Addendum to the Berths 302-306 APL Container Terminal Project Final Environmental Impact Report

APP No. 081203-131

October 17, 2016

TRANSMITTAL 4

Figure 1 – Approved Expansion Project at Full Buildout as Assessed in Final EIR

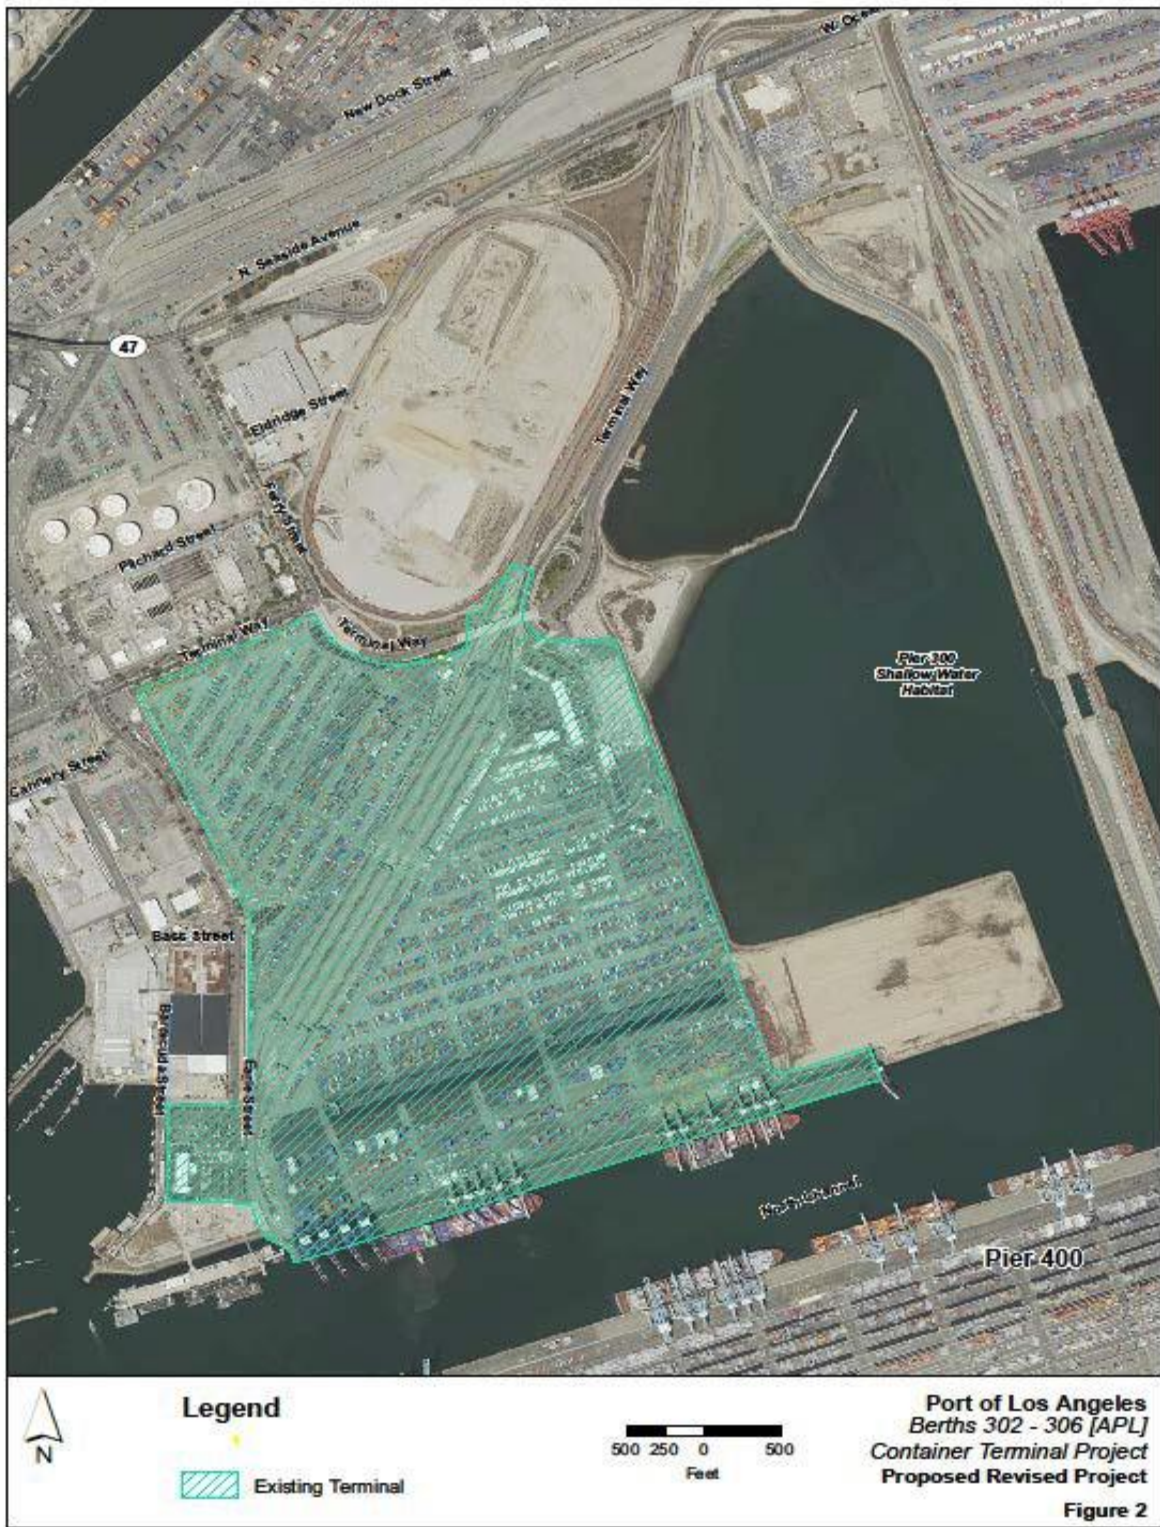
- The addition of 56 acres to the existing 291 acres to Berths 302-306;
- The construction of approximately 1,250 feet (4 acres) of concrete wharf to create Berth 306;

- The installation of up to 8 new cranes on the new wharf at Berth 306;
- The installation of Alternative Maritime Power (AMP) along the new wharf at Berth 306;

Figures 1 and 2 below highlight the Approved Expansion Project and the Proposed Revised Project.

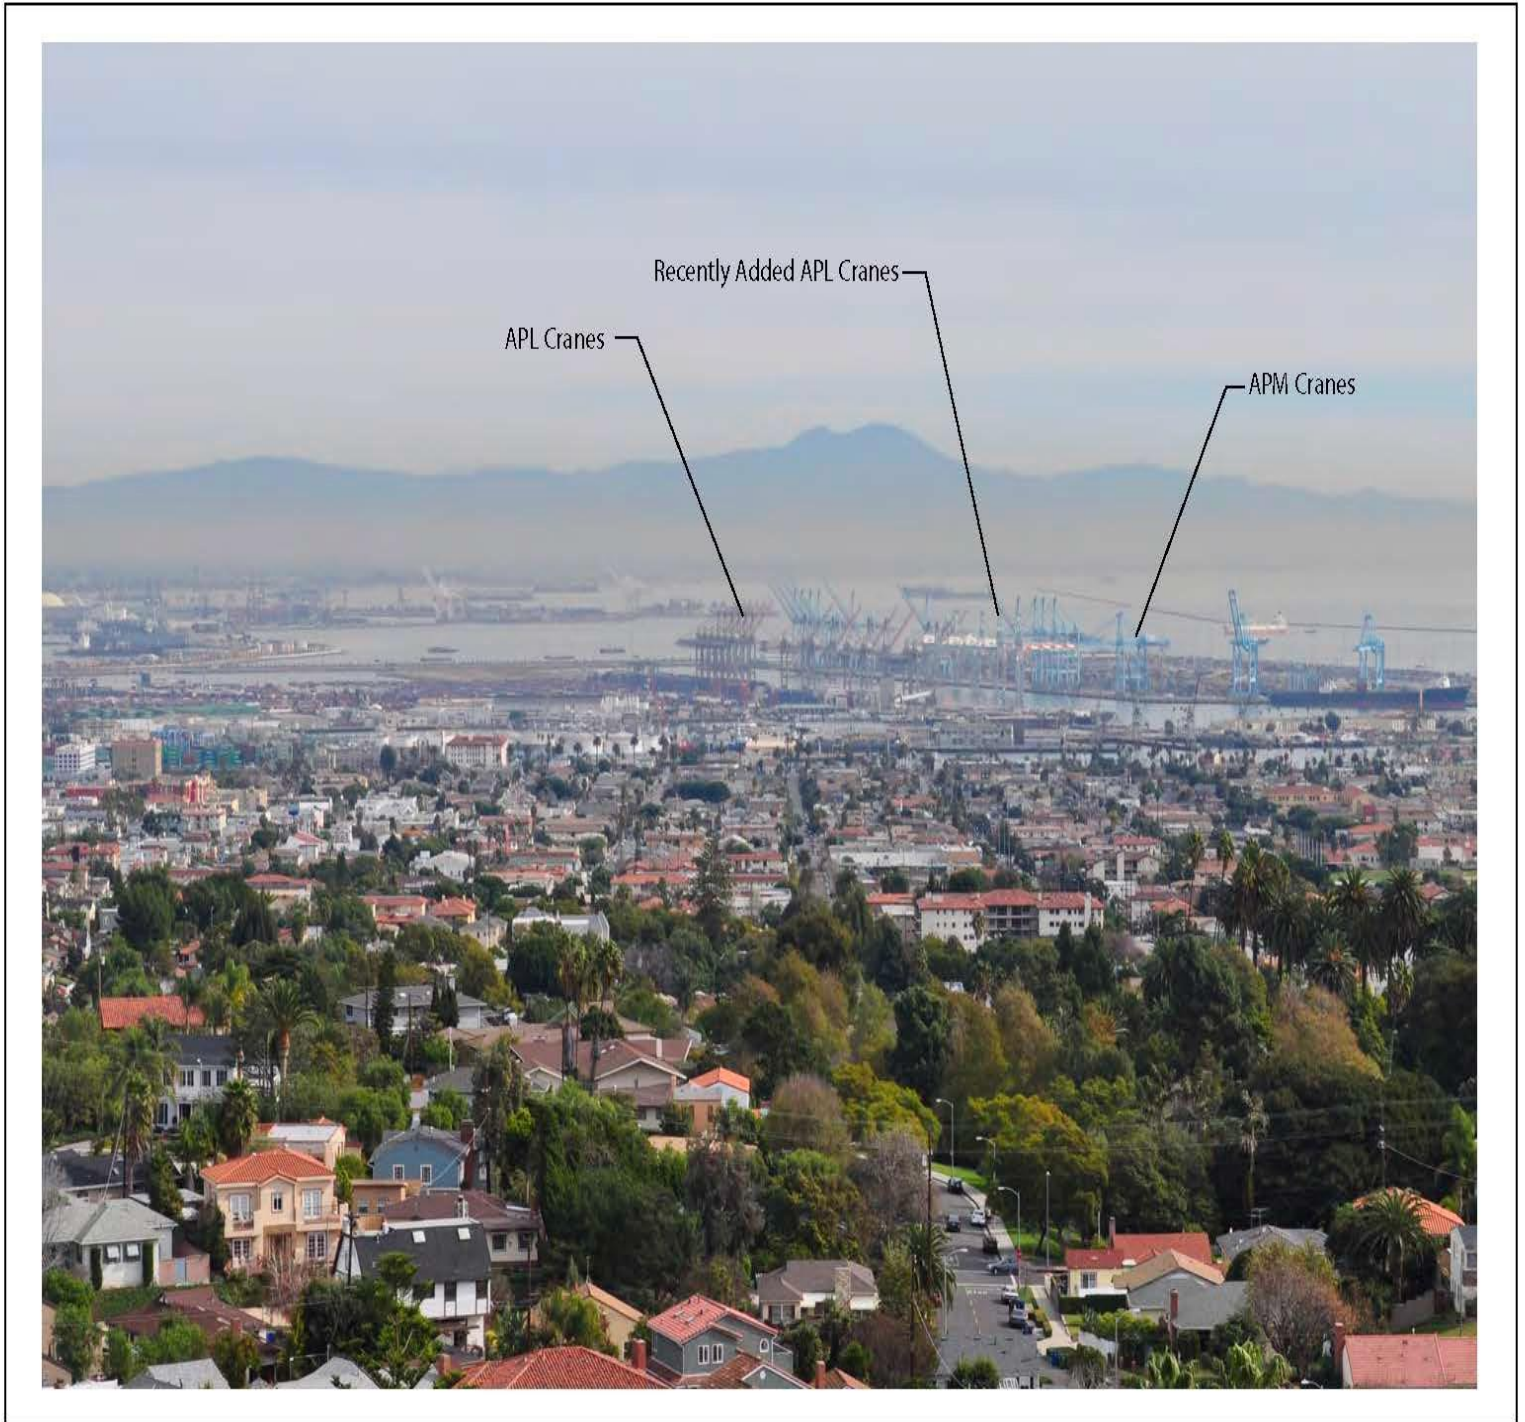
As described in Table 1, the Proposed Revised Project would have a maximum of 16 cranes located on Berths 302-305, the same number as approved for Berths 302-305 under the Approved Expansion Project. (The Approved Expansion Project also permitted eight cranes on Berth 306 which is not part of the Proposed Revised Project). For this reason, crane density impacts from the Proposed Revised Project would be the same or less than the Proposed Expansion Project and would therefore be less than significant for the same reasons as determined in the Final EIR (Ibid). Crane heights were also evaluated in the Final EIR. As described in Table 1, crane heights for the Proposed Revised Project would consist of 4 cranes equal in height to the 12 original Pier 300 facility cranes that were analyzed in the Final EIR (280’ in stowed position), 4 cranes equal in height to the 12 new cranes analyzed in the Final EIR (340’ in stowed position), and 8 new cranes (375’ in stowed position) that would replace 8 of the 12 original cranes.

To ensure that the 8 replacement cranes would not create an adverse aesthetics impact not previously identified in the Final EIR, a representative viewpoint from the Final EIR was revisited for a comparison

of density and crane height between existing conditions, the Approved Expansion Project and the Proposed Revised Project.

Figure 4
Looking Southeast from Deana Dana Friendship Park – Existing Setting

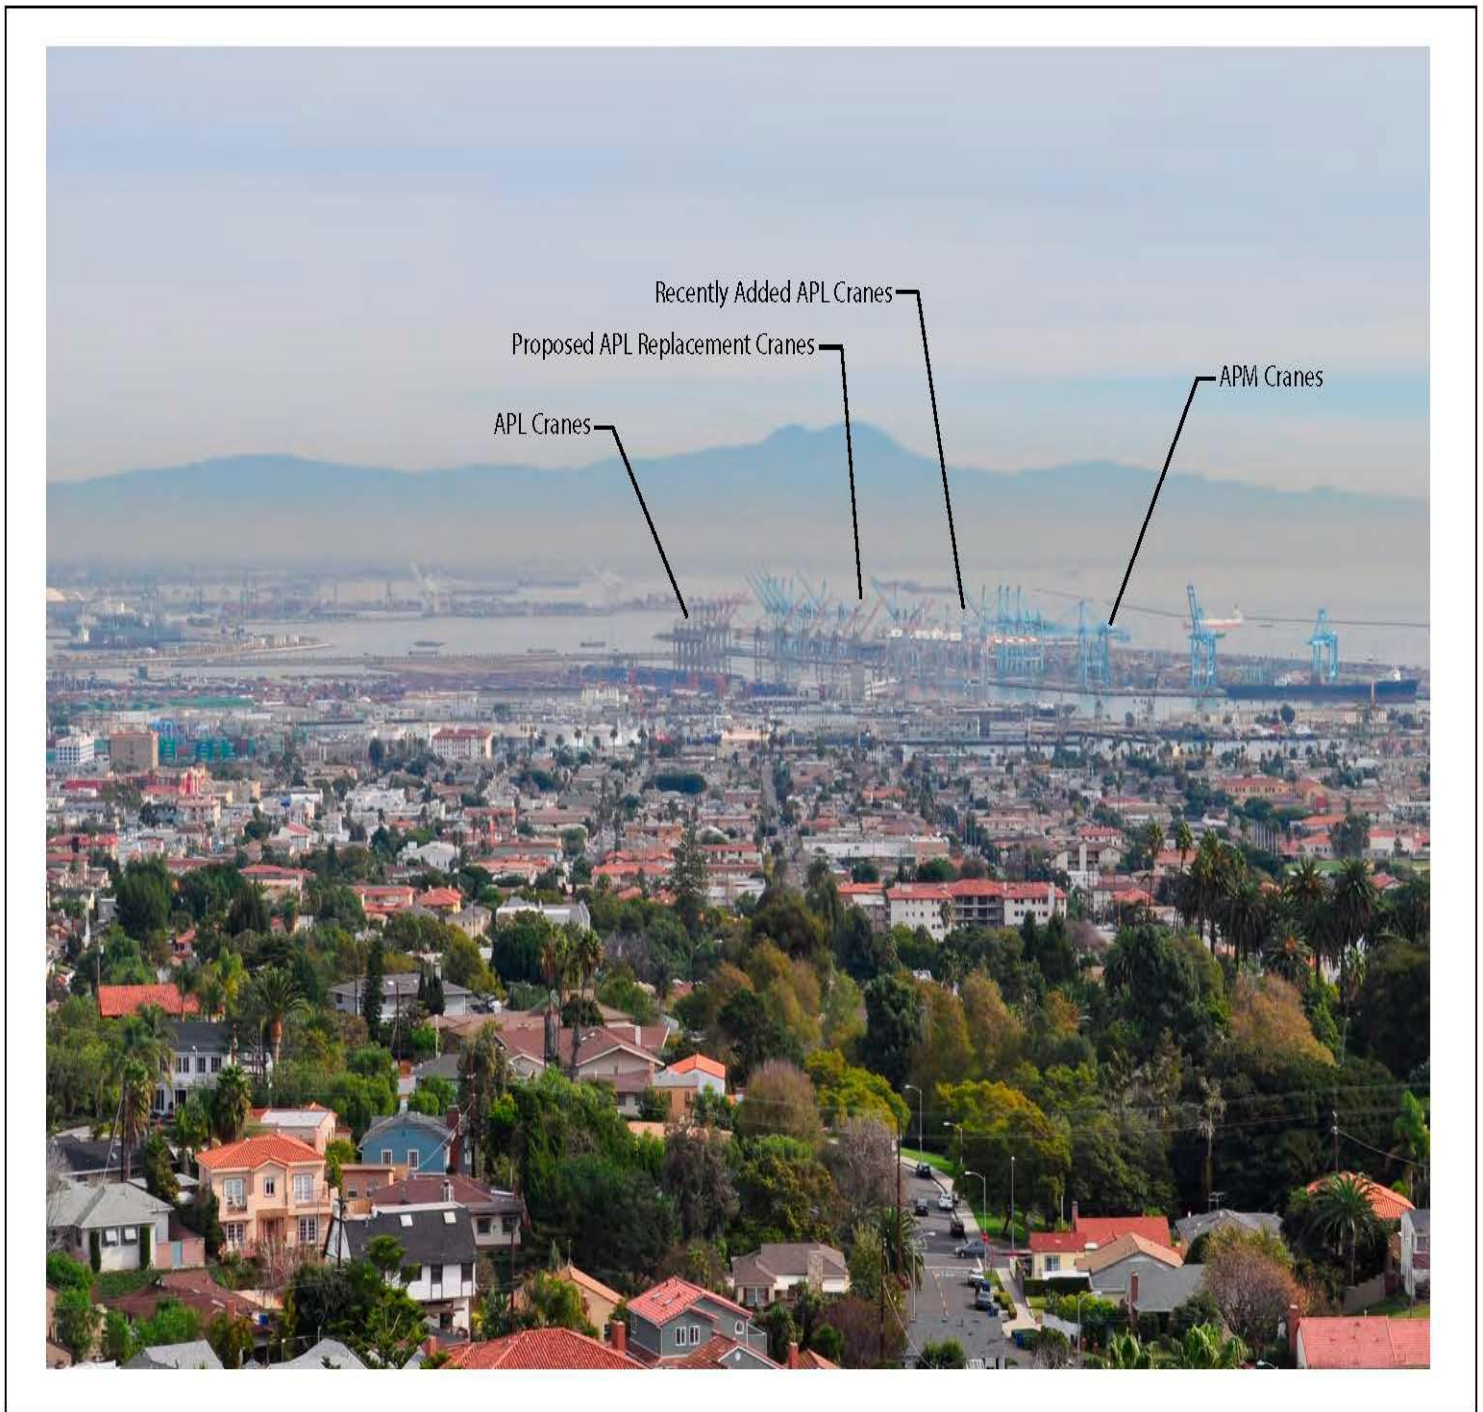
- The first simulation is the Proposed Revised Project showing four original cranes (280' in stowed position), four recently installed cranes (340' in stowed position as was analyzed in the Final EIR), and eight replacement cranes (375' in stowed position). This simulation also includes 12 new APMT cranes in the background that have also been raised to 375'. The APMT crane raising project was approved by LAHD in 2014 and crane-raising construction has begun. This simulation is shown in Figure 5.
- The second simulation is a reproduction of Figure 3.1-19 from the Final EIR, showing the Approved Expansion Project with 12 original cranes (280' in stowed position) together with the 12 new cranes (340' in stowed position) as it was analyzed in the Final EIR. This simulation is shown in Figure 6.

As can be seen, there is little difference between the photos showing the existing condition (Figure 4), the Proposed Revised Project (Figure 5) and the originally Approved Expansion Project (Figure 6), other than Figures 4 and 5 show less cranes than what was contained in the Approved Expansion Project.
